Re: Change Order: Field Turf

# Change Order Request 1 - PCO #3 - Final Turf Color Selections

602-BCPS High School Football Stadiums 3/16/2023

# **DPO Change Summary - COR-1 Final Turf Design**

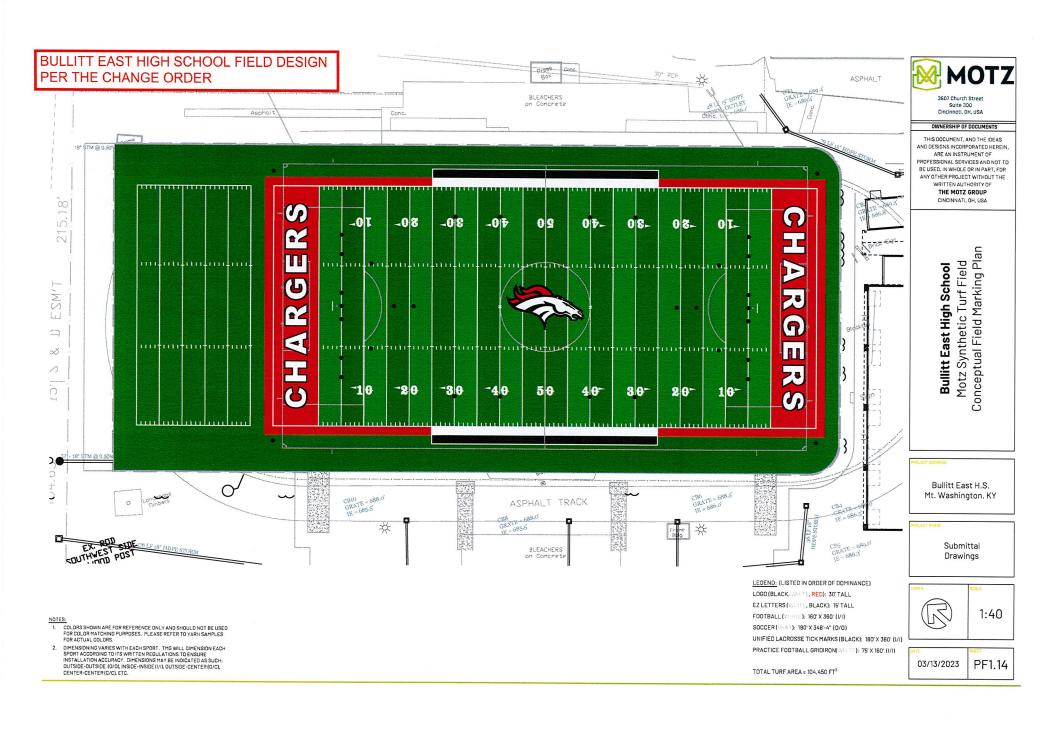
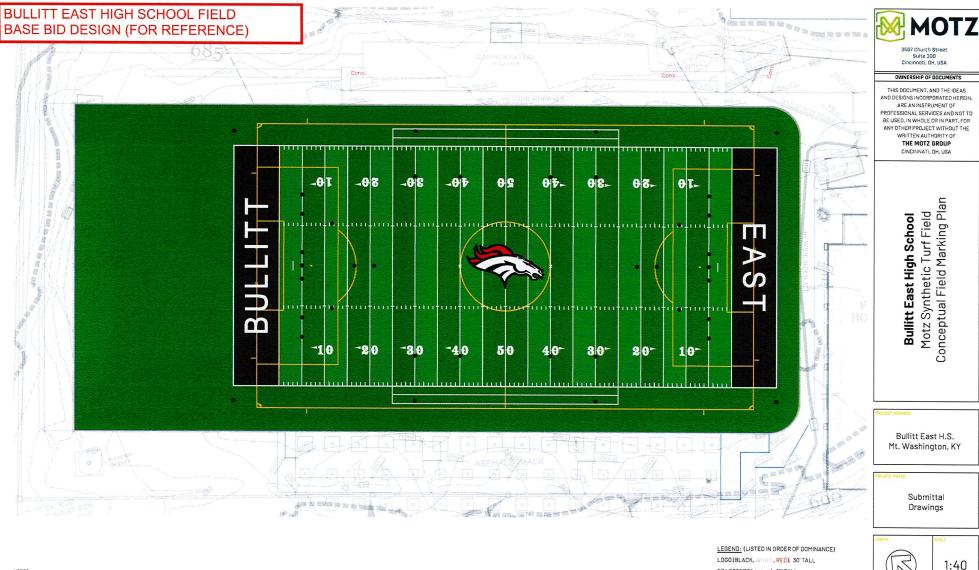
Scope -	Subcontractor	Description of Scope		Cost
1	BCPS Football Fields			
1.1	The Motz Group - DPO #17	Add for final turf designs		\$35,291.03
				\$35,291.03
	v		Total Amont	\$35,291.03
prove	d By:			Submitted By

PF1.0

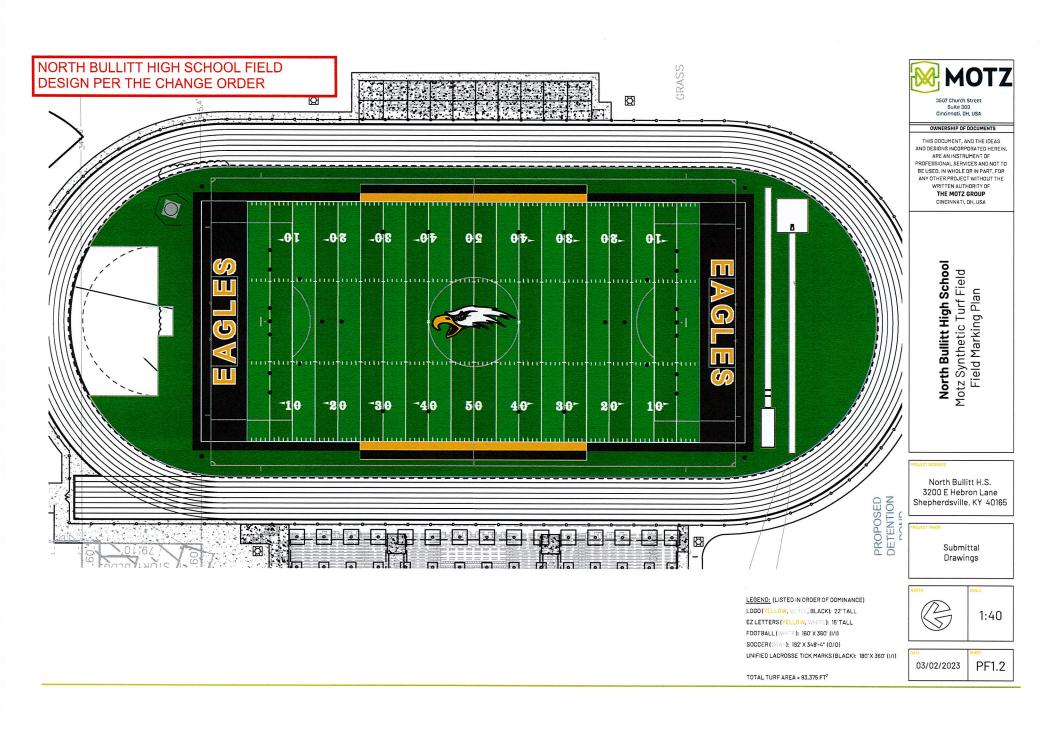
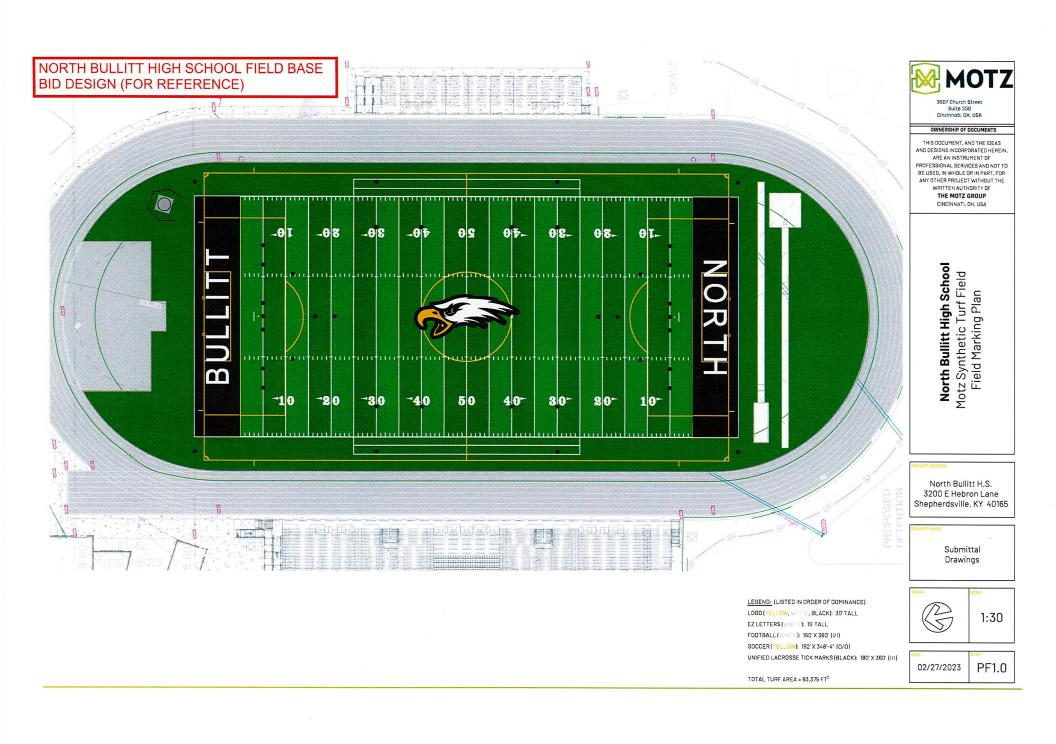
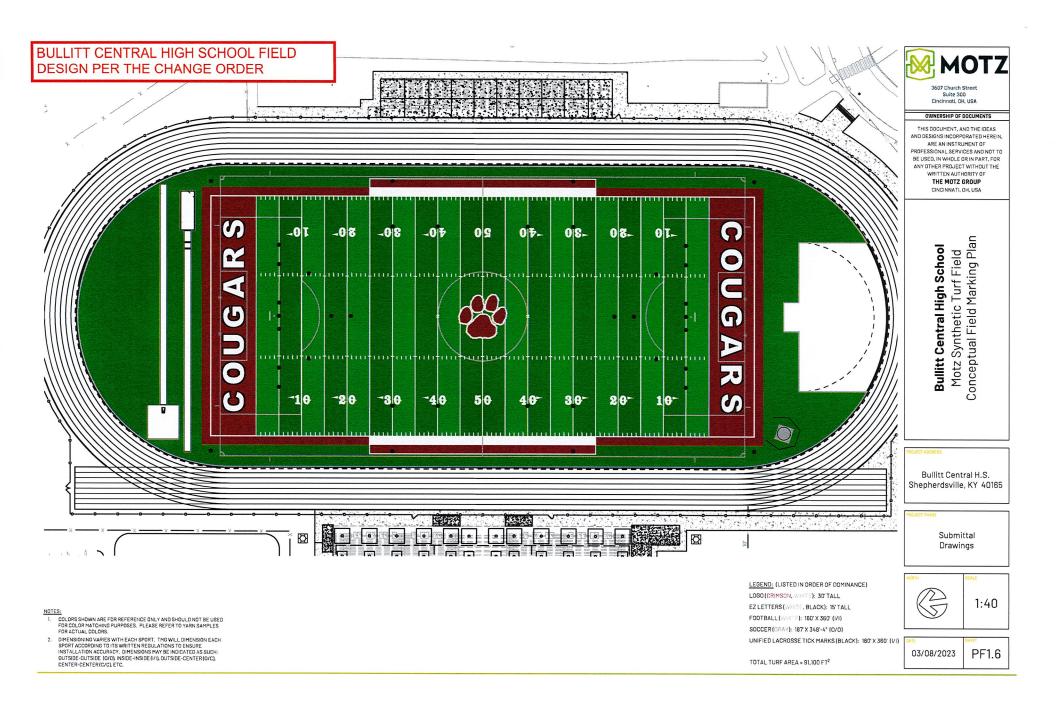
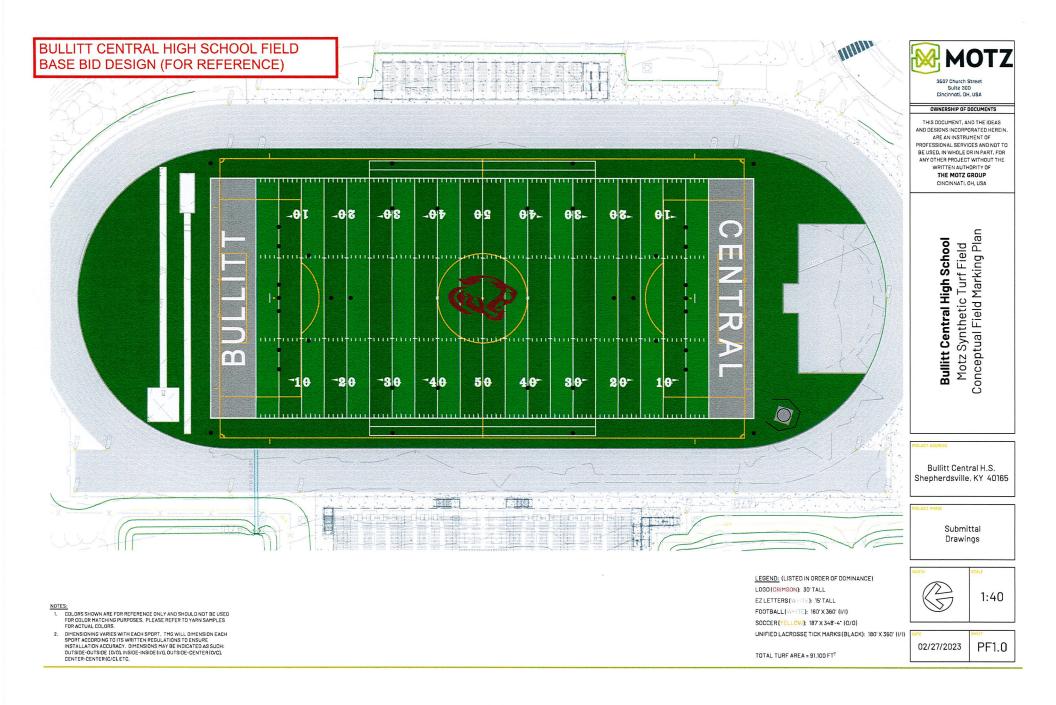
- 1.) Can an outline color be added to the Endzone lettering? Yes would be a change order as outlined numbers are a cost increase
- 2.) Can Soccer lines be gray instead of yellow? Yes, no problem (no cost change)
- 3.) Can a color be added inside the striping at the two player boxes at each sideline? The owner would like the endzone color to match these player boxes. Yes would be a change order as colors are slightly more cost than green.

- 4.) It looks like the soccer stripping differs at East where it cuts through the endzone lettering but then at North and Central it sits be above the endzone lettering. Each field layout should be the same. Let me know if we need to revise something at the East field. Soccer dimensions match drawings I can have these changes made to make them all the same (no cost change)
- 5.) BCPS would like to add practice stripping at the plan left side of the East field. I can send that over to you later this morning. Ok would be a change order for the additional striping.

Additional colored turf design for lettering outlines at endzones, multicolored player boxes, field border at all three fields and grid iron design at Bullitt East west endzone. This Change Order covers additional material costs under a District Purchase Order.

Scope includes the labor to add a grid-iron per the attached field design at the west endzone at Bullitt East High School.
